# Modification of Development Consent

Application Number: 06\_0228  
Applicant: Shoalhaven Starches Pty Ltd  
Consent authority: Minister for Planning  
Development: Shoalhaven Starches Expansion Project  
Date of original approval: 29 January 2009  
Modification: 06\_0228 MOD 16 – Flour, Starch and Gluten Increase

# APPENDIX 2P – SITE PLANS (MP 06\_0228 MOD 16)

Location of MOD 16 Components

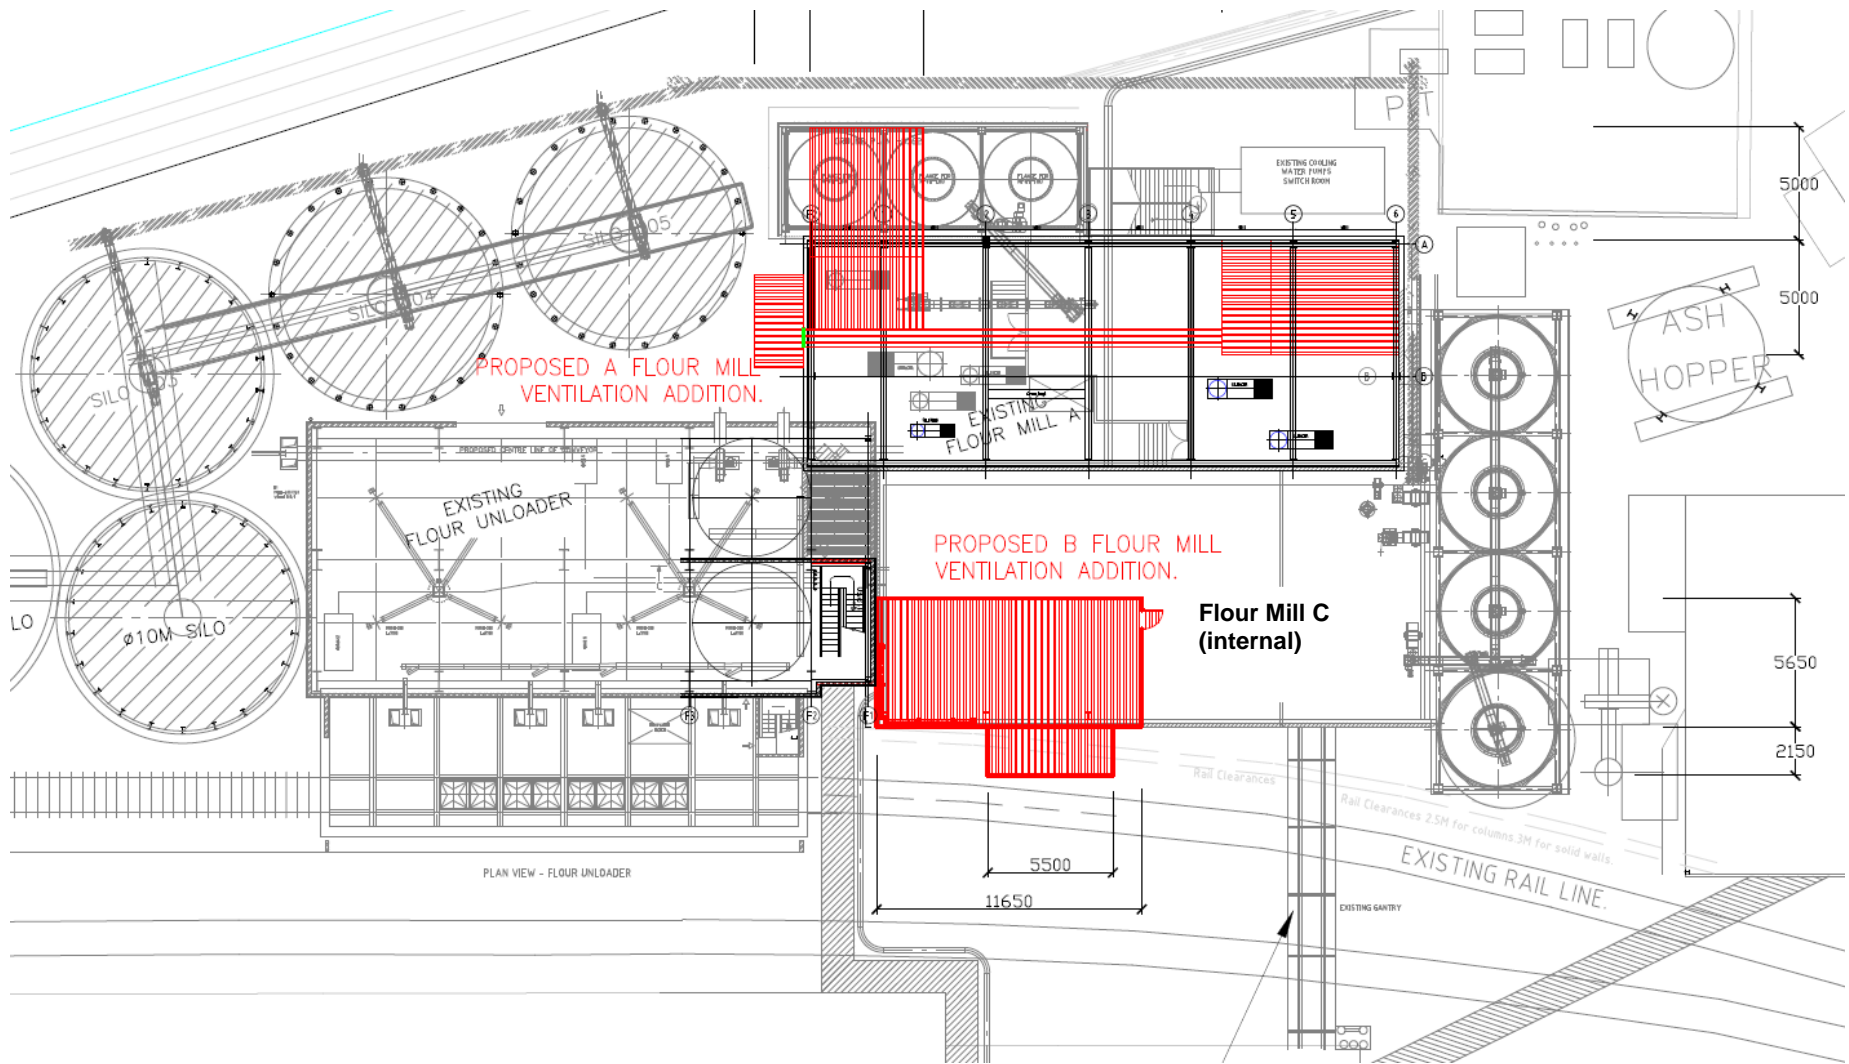
EXISTING — BLACK.  
 NEW PROPOSALS — RED.  
 MODS 3 & 12 APPROVALS — BLUE.
